# Access Compliance Report

## Public Rights-of-Way

### (Curb Ramps)

Intersection ID: 47573	Main Street: SEDGEBURN_DR	Cross Street: GAILES_DR	Location: NW
ADA ID: E6A77E7445A2	Ramp Type: PerpDiag	Initial Pass/Fail: Fail	Overall Compliance: No
Severity Score: 8.75			
Codes/Mitigation Info/Possible Solution		Field Measurements/Component Compliance

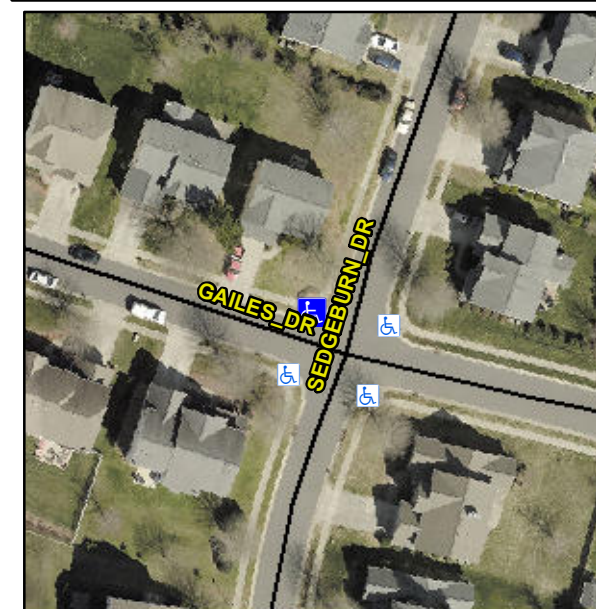
**R304.5.1**

Compliance	Description	Data	Compliance	Description	Data
N/A	Ramp Length (in)	47.0	Yes	Ramp Slope (%)	7.0
No	Ramp Width (in)	44.0	Yes	Ramp XSlope (%)	0.5
N/A	Flare Type LT	N/A	N/A	Flare Type RT	N/A
N/A	Flare Slope LT (%)	N/A	N/A	Flare Slope RT (%)	N/A
N/A	Flare Traversable LT?	N/A	N/A	Flare Traversable RT?	N/A
N/A	Landing Length (in)	N/A	N/A	DWS Provided?	N/A
N/A	Landing Width (in)	N/A	N/A	DWS Contrast?	N/A
N/A	Landing Slope (%)	N/A	N/A	DWS Length (in)	N/A
N/A	Landing X Slope (%)	N/A	N/A	DWS Full Width?	N/A
N/A	Landing Curb? (Y/N)	N/A	N/A	DWS Offset (in)	N/A
N/A	Shared Landing?	N/A			
N/A	Gutter Ponding?	N/A	N/A	Gutter Slope (%)	N/A
N/A	Gutter Lip Ht (in)	N/A	N/A	Gutter X Slope (%)	N/A
N/A	Painted X Walk1?	No	N/A	Painted X Walk2?	No
	X Walk 1 Direction	To SW		X Walk 2 Direction	To SE
N/A	X Walk 1 Width (in)	N/A	N/A	X Walk 2 Width (in)	N/A
	X Walk 1 Slope (%)	0.9		X Walk 2 Slope (%)	3.3
	X Walk 1 X Slope (%)	1.6		X Walk 2 X Slope (%)	2.5

N/A	Ramp inside XWalk1?	N/A	N/A	Ramp inside XWalk2?	N/A
	Road Slope (%)	1.0	N/A	Clear Space?	N/A
	Road X Slope (%)	4.9	N/A	Clear Space to XWalk (in)	N/A
N/A	Any Obstructions?	N/A	N/A	Storm Grate/Utility Hazard?	N/A
	Obstruction Type			Storm Grate/Utility Type	
		N/A			N/A
			Yes	Surface Condition? (G/P)	Good

**Remove & Replace Curb Ramp With Two New Directional Ramps or Equivalent.**
